Mr. Richard K Struckmeyer  
Materials Safety Licensing Branch  
Division of Materials Safety, State, Tribal, and Rulemaking Programs  
Office of Nuclear Material Safety and Safeguards  
U.S Nuclear Regulatory Commission  
Mail Stop: T-8E 18  
Washington DC 20555

This letter is in response to your mail dated on Dec 1<sup>st</sup>, 2017 regarding about requesting additional information for our exempt distribution license.

**PLEXUS SCIENTIFIC CORPORATION**  
RADIOLOGICAL SURVEY FORM

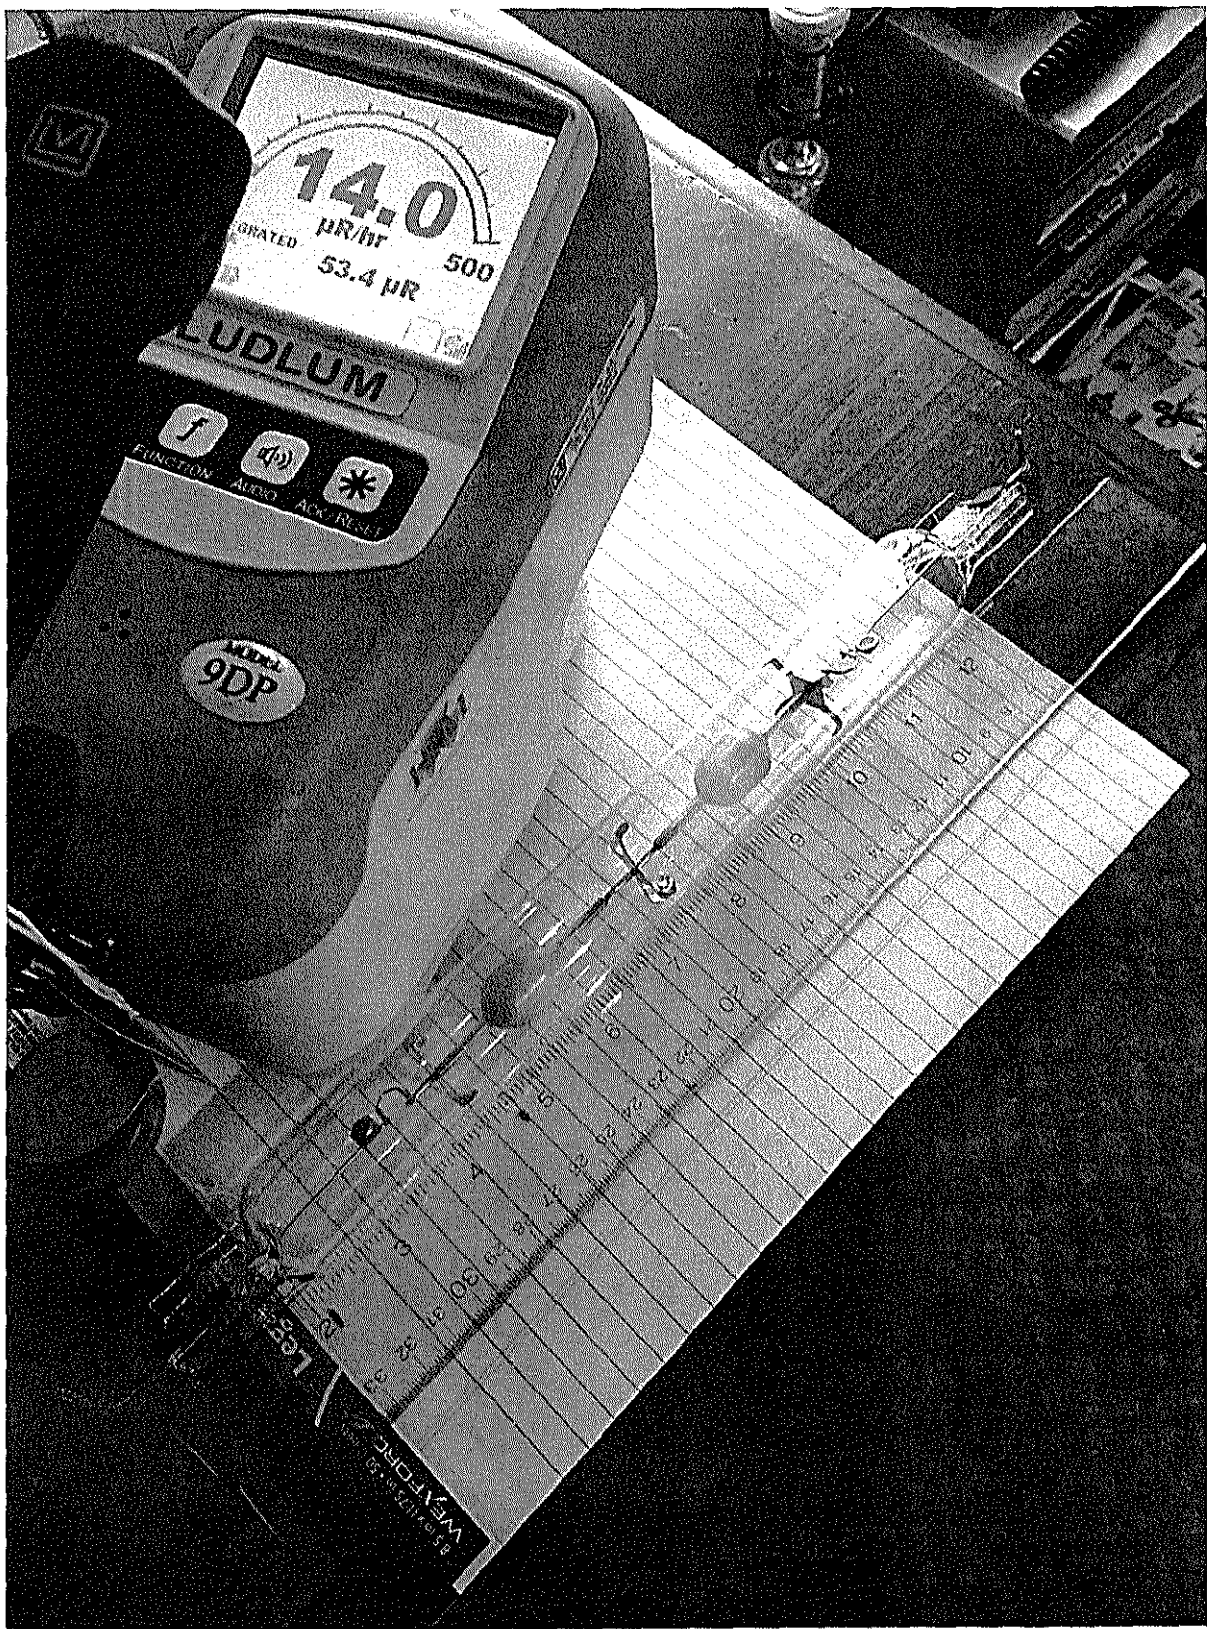
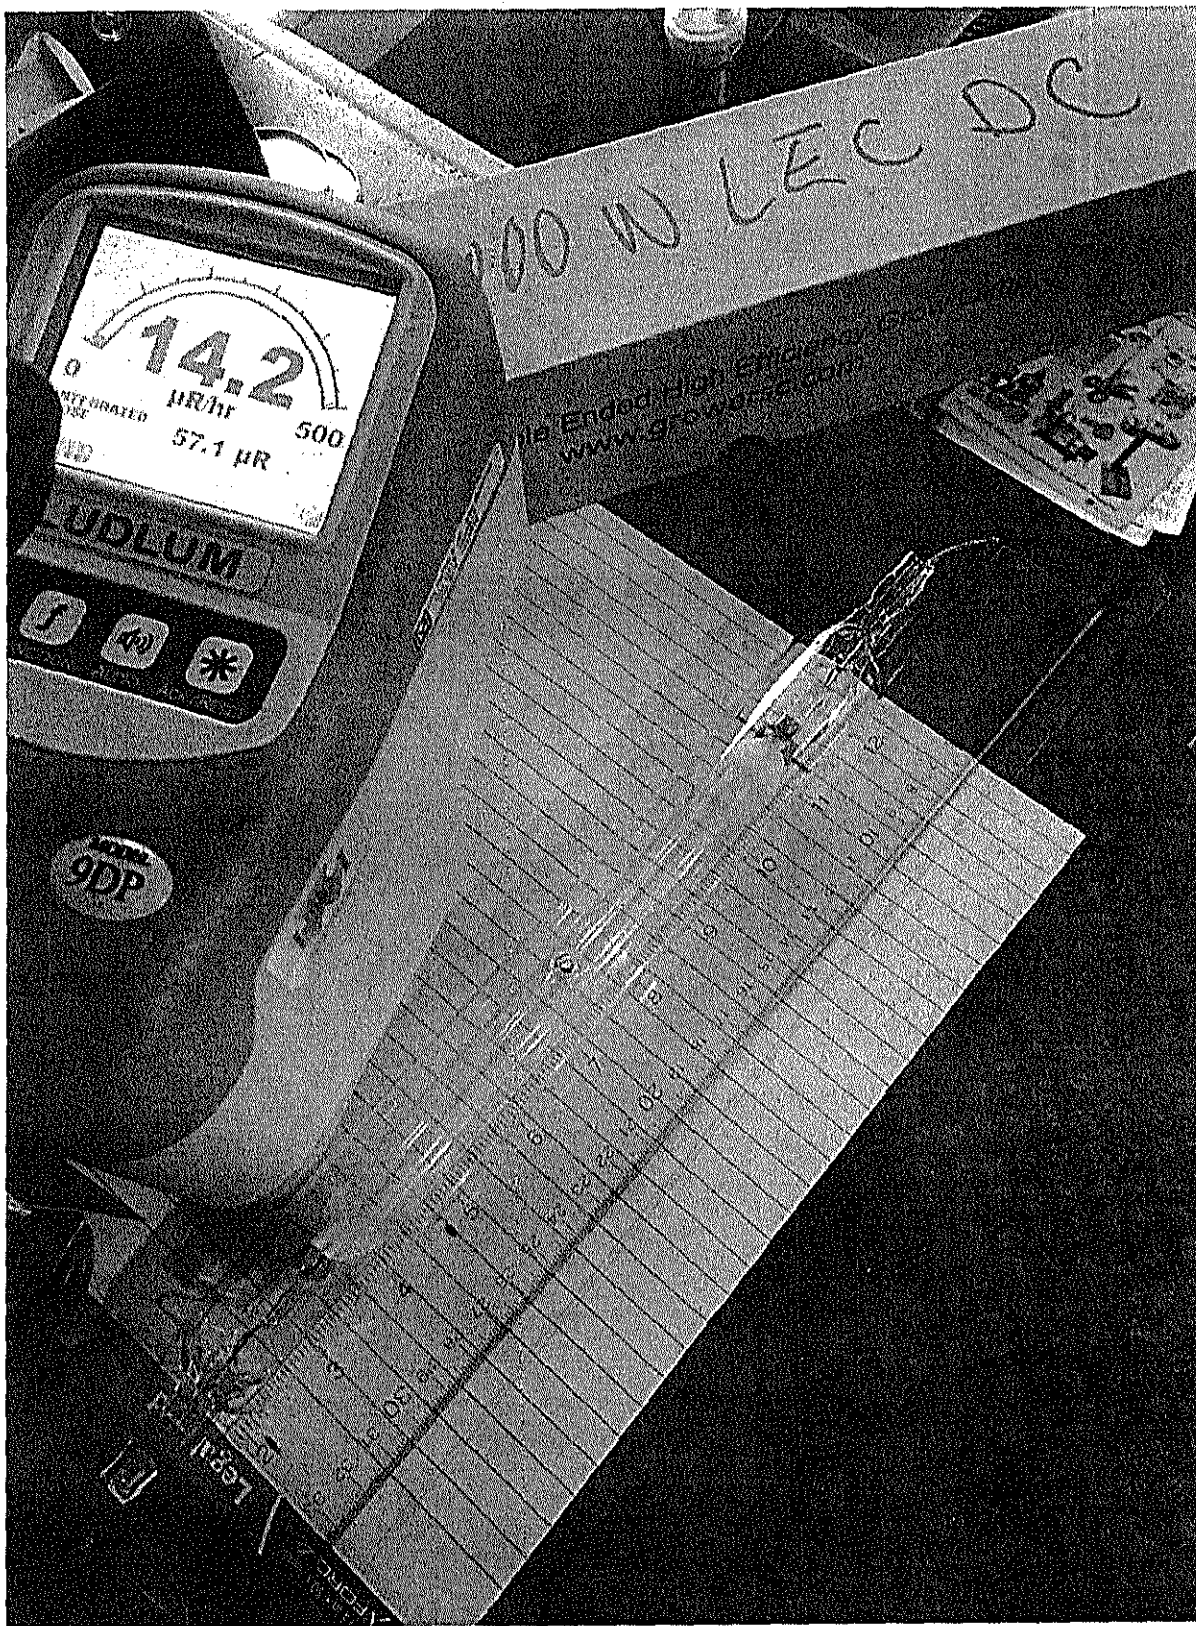
6. Please indicate how you made this determination; i.e., your method of measurement or calculation.

All of calculation and method of measurement is made by the consulting company PLEXUS SCIENTIFIC CORPORATION RADIOLOGICAL SURVEY FORM. They are one of the certify organization that has the ability to perform this kind of measurement.

Notes: Background Readings 11  $\mu$ R/hr - 15  $\mu$ R/hr.

- All lamps readings equal to background levels.
- Photographs attached
- Instrument Cal. Cert. in Certificate attached.
